20LC-037

MEMORANDUM

RE: **20LC-037 (1801 Avenue L) Request for the Landmark Commission to reconsider this request regarding a Certificate of Appropriateness.** Request for a Certificate of Appropriateness for alterations to the structure including painting exterior masonry, replacing exterior doors, and removing exterior shutters. Property is legally described as M. B. Menard Survey, North 67-8 Feet of Lot 7 (7-1), Block 18, in the City and County of Galveston, Texas.
Applicant: Becky Jolin
Property Owner: Sam and Becky Jolin

STAFF REPORT

1801
AVE-L

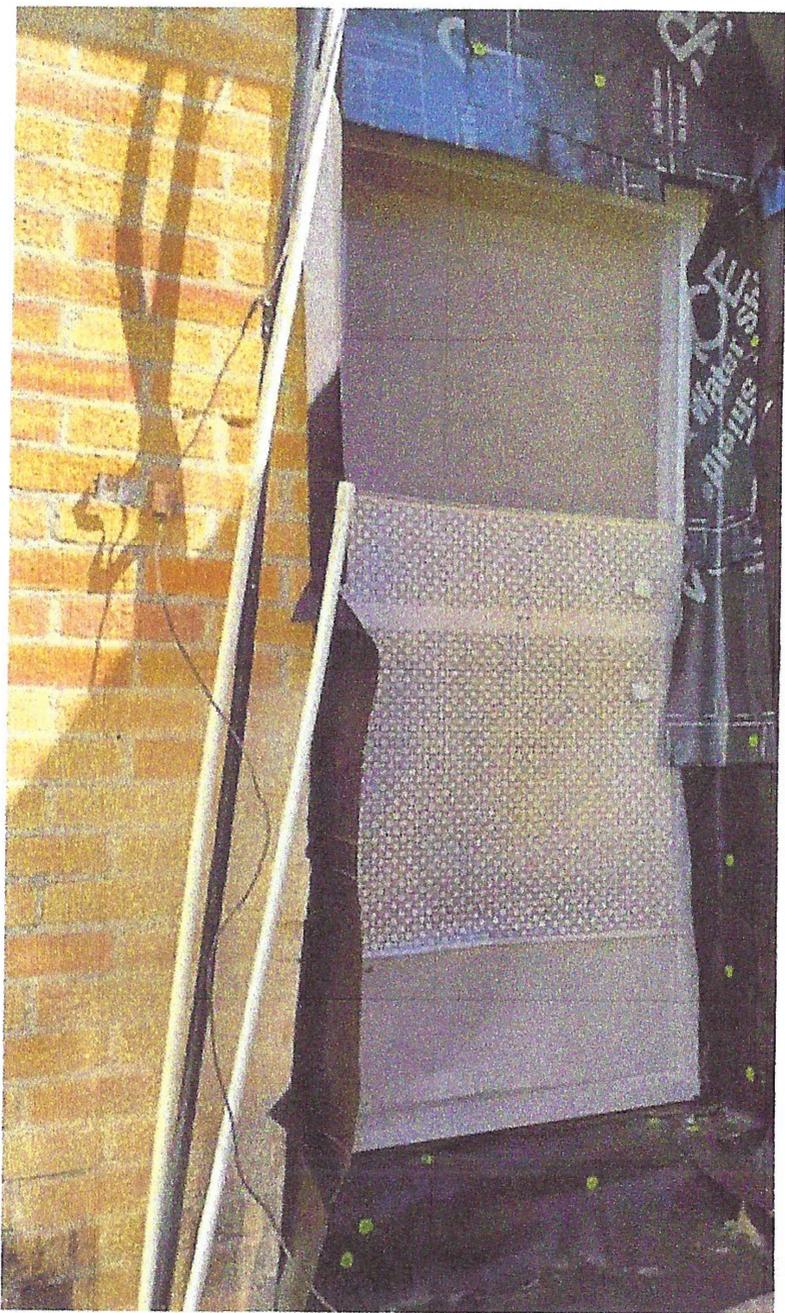
The *Design Standards* discourage painting masonry that was not painted historically. Presently, portions of the masonry walls on the ground floor are painted. Staff finds that repainting these portions is appropriate. However, since staff was not provided with evidence that the rest of the structure has been painted historically, staff recommends that the unpainted masonry walls remain unpainted.

There are existing painted wall signs on the 18th Street and Avenue L facades. The *Design Standards* encourage the preservation of these “ghost signs” whenever possible. Staff recommends that the existing signs are left exposed.

- 1) The applicant shall conform to the design, material, and placement shown in Attachment A of the staff report with the following modifications:
 - a. The unpainted masonry shall not be painted;
 - b. The existing painted wall sign shall remain exposed; and
 - c. The proposed Door 1 shall be omitted in favor of double wood impact doors with single lites.

Existing Front Door 1
to commercial space

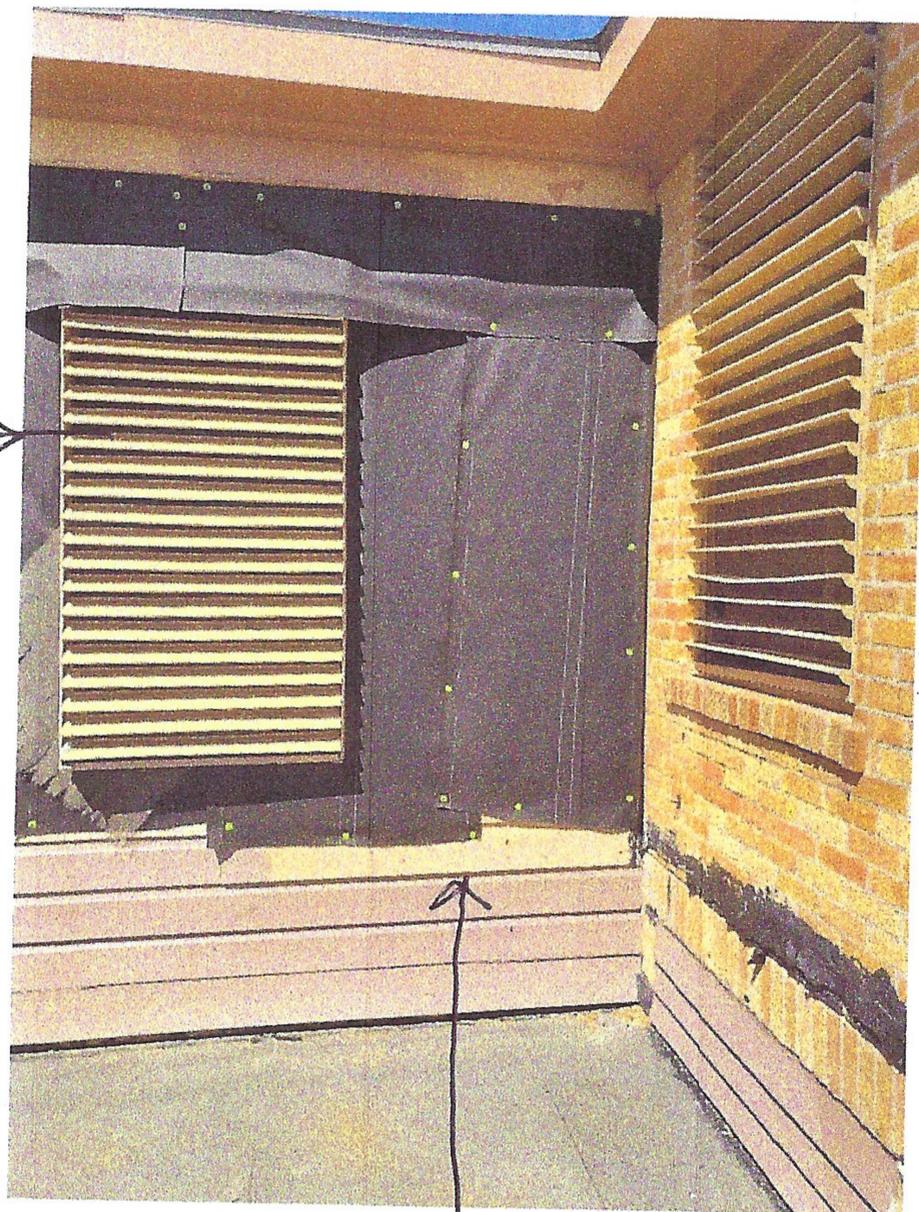
Door 1: While wooden doors with sidelights are common in the historic districts, the *Design Standards* encourage preservation of the position, dimensions, and decorative features of doors on primary facades. Without evidence that a single door with sidelights existed at this location, staff finds the proposed door inappropriate. As an alternative, the applicant has proposed double wood impact doors with single lites in the existing configuration. Staff finds the double doors more appropriate.

Existing Door 5
at top of backyard
stairs
(this room had extensive
fire damage that's repaired.)

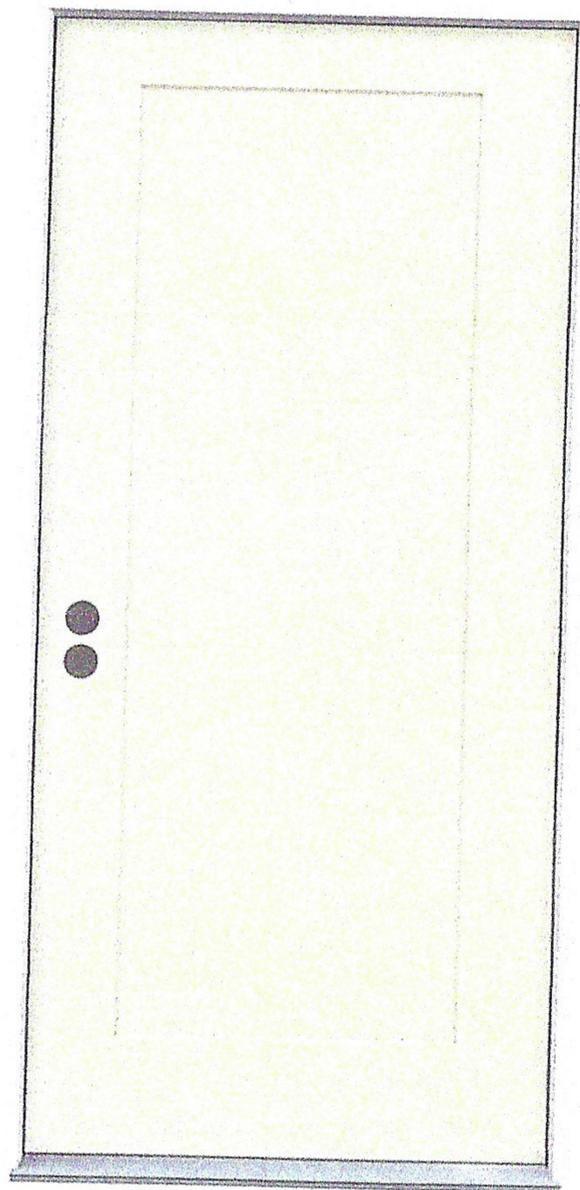
Doors 5, 6, and 7: While the *Design Standards* encourage replacement doors to match the originals in material and design, doors 5, 6, and 7 are located in Location C: Less Visible Secondary Wall. Preservation is still preferred but additional flexibility exists for compatible replacement or alteration.

According to the applicant, the windows on the south façade over the 1970s addition are aluminum. While the *Design Standards* discourage the enclosure of historic window openings and staff prefers that the replacement windows match the historic windows in design and material, the windows are located in Location C: Less Visible Secondary Wall. Preservation is still preferred but additional flexibility exists for compatible

replacement or alteration. Staff finds the proposed changes to the windows appropriate due to their location on the south façade.

Proposed Door 3 - Entry to Residence
Will paint Trim color
36" x 83"

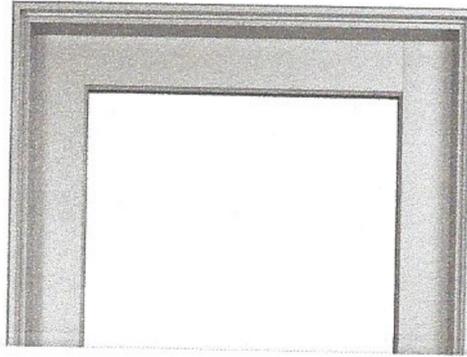
Doors 2 and 3: When replacing a historic door, the *Design Standards* encourage using a design that matches that of the original door. Without evidence of what the original door looked like, staff finds that a simple design is appropriate.
